Town of Paradise Valley

Meeting Notice and Agenda Planning Commission

**A. [19-082](#) Discussion of Major Special Use Permit Amendment (SUP-18-05)
7101 E Lincoln Drive - Smoke Tree Resort Study Session #8**

Attachments: [Attachment A - Application](#)
 [Attachment B - Vicinity Map & Related Maps](#)
 [Attachment C.1 - Revised Narrative and Plans \(02/12/2019 Application Booklet\)](#)
 [Attachment C.1a - Conceptual South Patio Plans](#)
 [Attachment C.1b - Quail Run Roadway Section](#)
 [Attachment C.2 - Traffic Impact Analysis](#)
 [Attachment C.3 - Parking Analysis and Comment Responses](#)
 [Attachment C.4 - Preliminary Drainage Report](#)
 [Attachment C.5 - Water Impact Study](#)
 [Attachment D - SUP Guidelines](#)
 [Attachment E - General Plan Policies](#)
 [Attachment F - SUP History](#)
 [Attachment G - Smoke Tree Statement of Direction](#)
 [Attachment H - Public Comments as of 02/13/2019](#)
 [Attachment I - Lincoln Median Access Report](#)
 [Attachment J - DRAFT Ordinance 2019-02](#)
 [Attachment K - Applicant's Redlines to DRAFT Ordinance 2019-02](#)

SITE PLAN REVISIONS

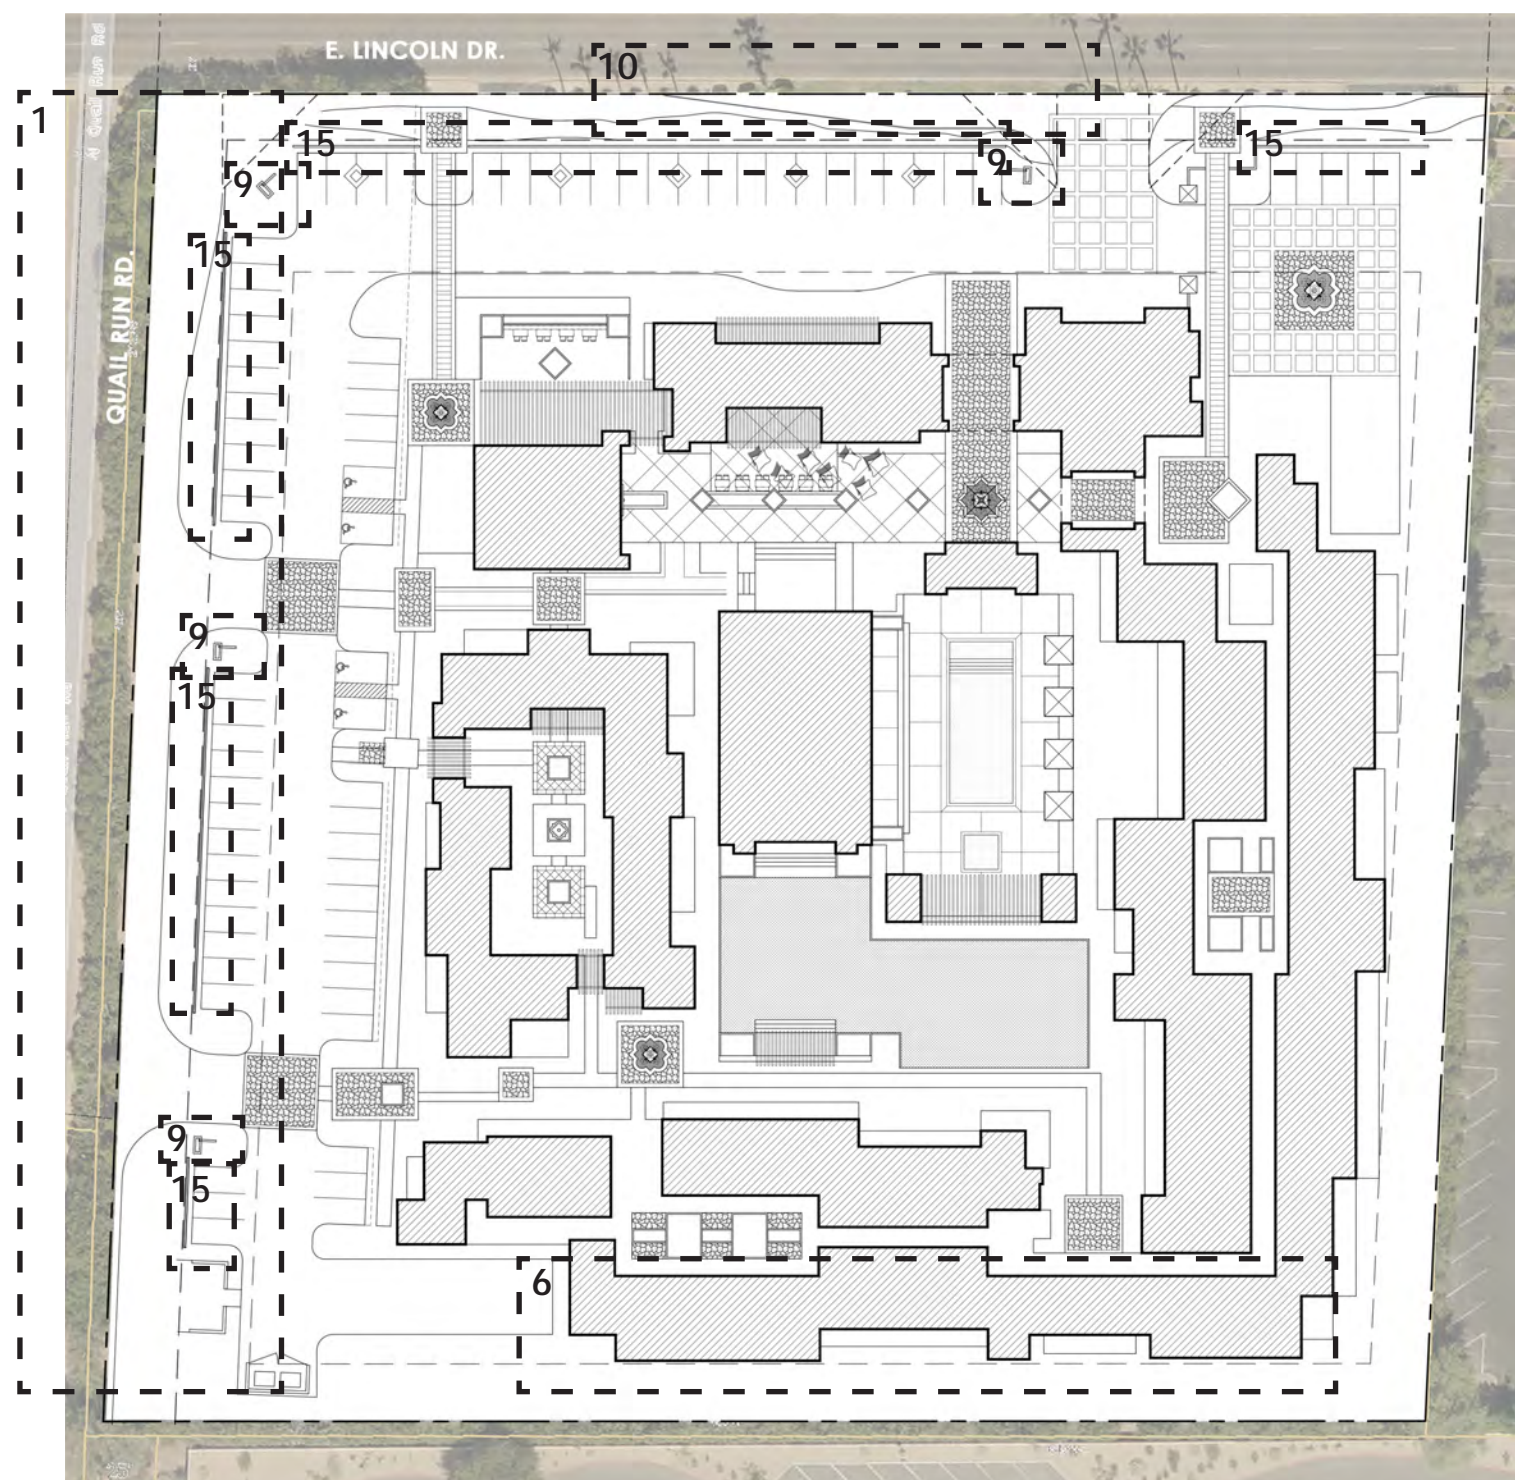
REVISIONS 02-12-2019

1. Quail Run Road - It is centered on the existing Property Line, which in turn should align with Palmerie Blvd across Lincoln Drive. Quail Run Road will be two lanes, 22' width of asphalt, 11' per lane, with an additional 2' curb on each side. The total width of improvements to be 26'. There will also be 12' of landscaping on the East side of the new curb.

3. Garage parking spaces count - 2 parking spaces per Dwelling Unit will be provided. Please refer to the attached preliminary parking study for detail.

6. South Property Line - Andaz - Open Space Criteria (OSC) - step the building back from the South property line - the building adjacent to the South property line has been redesigned per this request. The Set Back Exhibit has been revised to reflect a two-story building stepping back to a three-story maximum. A revised Open Space Criteria Section has been attached.

7. Density - Door count - total door count reduced to 165. As part of the redesign to move units away from the South Property line, 15 of the lock-off doors were eliminated to provide a more efficient use of space and access. The revised door count is comprised of 120 hotel doors, 30 residential doors of which 15 have a lock-off feature.

8. Open Space Criteria - the revised proposed Amendment complies with the OSC on the West boundary (which is adjacent to residential property) and the North boundary on Lincoln Drive, which is a Visually Significant Corridor, with limited encroachment on the South and East boundaries

15. Parking screen walls have been added in front of all parking spaces along Lincoln and Quail Run Road that face the roadways.

Figure 4.2 Process for Selecting Average Rate or Equation
in Trip Generation Manual Data

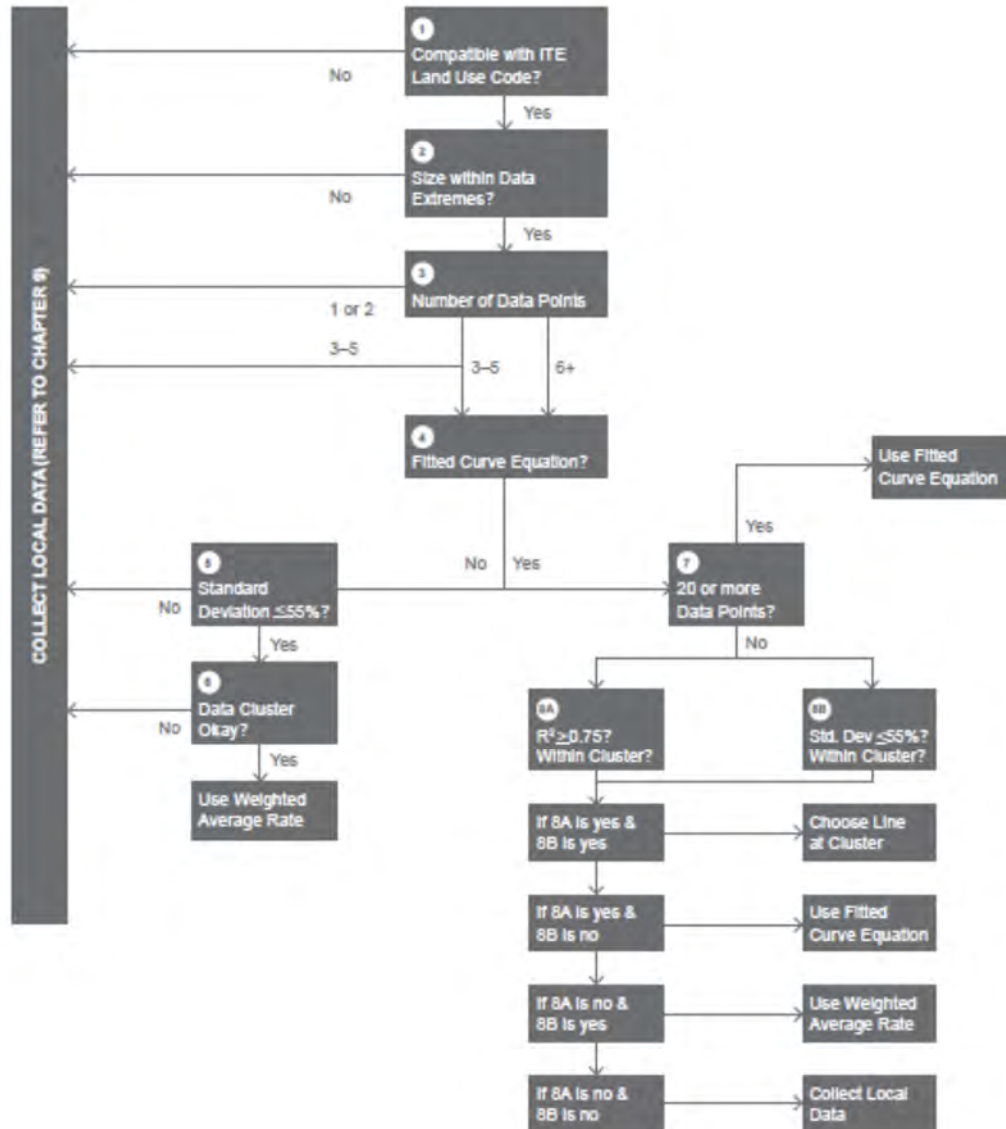
KH Comments 4: Smoke Tree Resort utilized equations as opposed to average rates. KHA went through the ITE Trip Generation Handbook process presented in Figure 4.2 assuming proposed number of units for resort hotel (LUC 330). The results of this process are presented below and KH redlines provided in **Appendix 1**.

Kimley-Horn Comments on
CivTech Access Assessment Option 1 through 3

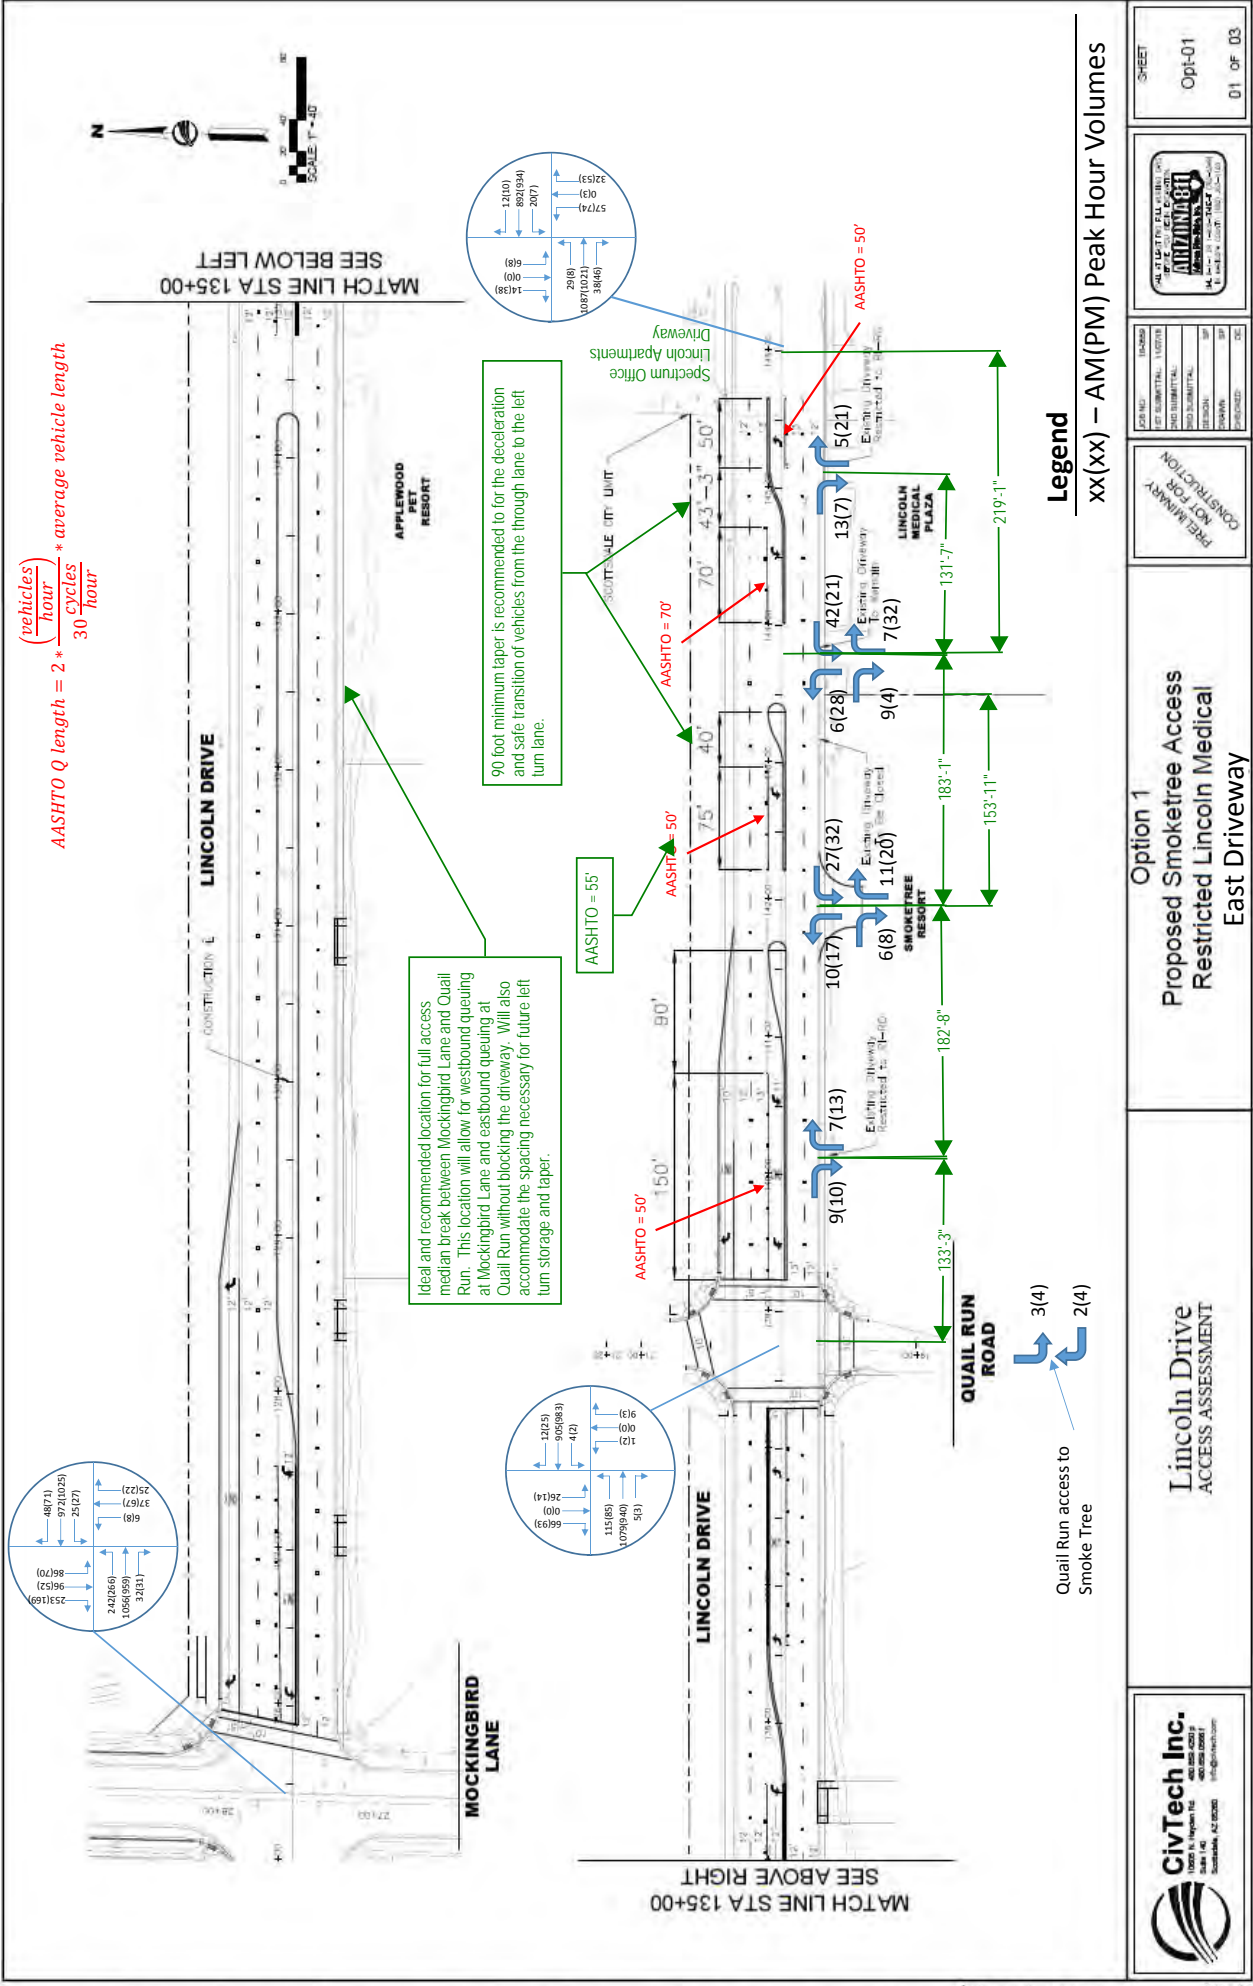
$$\text{AASHTO } Q \text{ length} = 2 * \frac{\left(\frac{\text{vehicles}}{\text{hour}}\right)}{30 \text{ cycles}} * \text{average vehicle length}$$
